# Access Compliance Report

## Public Rights-of-Way

Intersection ID: 10020376	Main Street: BALLANTYNE CORPORATE PK	Cross Street: N/A	Location:	S
ADA ID: AE4F4D5E778E	Ramp Type: Perp	Initial Pass/Fail: Fail	Overall Compliance: No	Severity Score: 12.5
Codes/Mitigation Info/Possible Solution		Field Measurements/Component Compliance

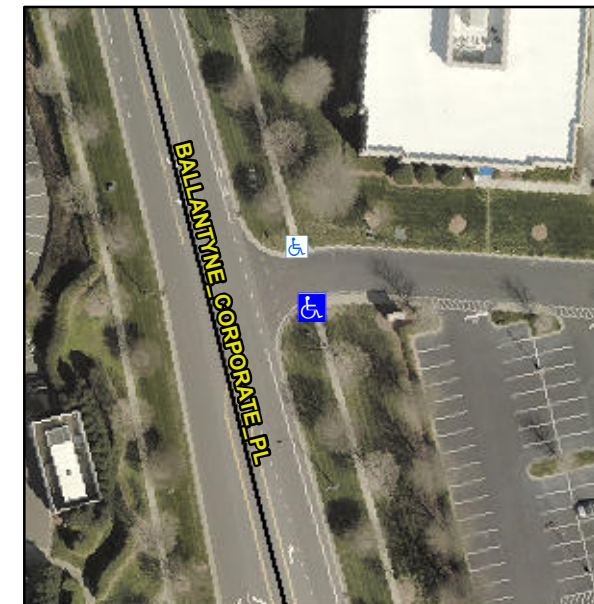
Compliance	Description	Data	Compliance	Description	Data
N/A	Ramp Length (in)	64.0	Yes	Ramp Slope (%)	7.3
Yes	Ramp Width (in)	48.0	No	Ramp XSlope (%)	6.0
N/A	Flare Type LT	N/A	N/A	Flare Type RT	N/A
N/A	Flare Slope LT (%)	N/A	N/A	Flare Slope RT (%)	N/A
N/A	Flare Traversable LT?	N/A	N/A	Flare Traversable RT?	N/A
N/A	Landing Length (in)	N/A	N/A	DWS Provided?	N/A
N/A	Landing Width (in)	N/A	N/A	DWS Contrast?	N/A
N/A	Landing Slope (%)	N/A	N/A	DWS Length (in)	N/A
N/A	Landing X Slope (%)	N/A	N/A	DWS Full Width?	N/A
N/A	Landing Curb? (Y/N)	N/A	N/A	DWS Offset (in)	N/A
N/A	Shared Landing?	N/A			
N/A	Gutter Ponding?	N/A	N/A	Gutter Slope (%)	N/A
N/A	Gutter Lip Ht (in)	N/A	N/A	Gutter X Slope (%)	N/A
N/A	Painted X Walk1?	No	N/A	Painted X Walk2?	N/A
	X Walk 1 Direction	To N		X Walk 2 Direction	N/A
N/A	X Walk 1 Width (in)	N/A	N/A	X Walk 2 Width (in)	N/A
	X Walk 1 Slope (%)	4.2		X Walk 2 Slope (%)	N/A
	X Walk 1 X Slope (%)	4.9		X Walk 2 X Slope (%)	N/A

**Remove & Replace Entire Ramp.**
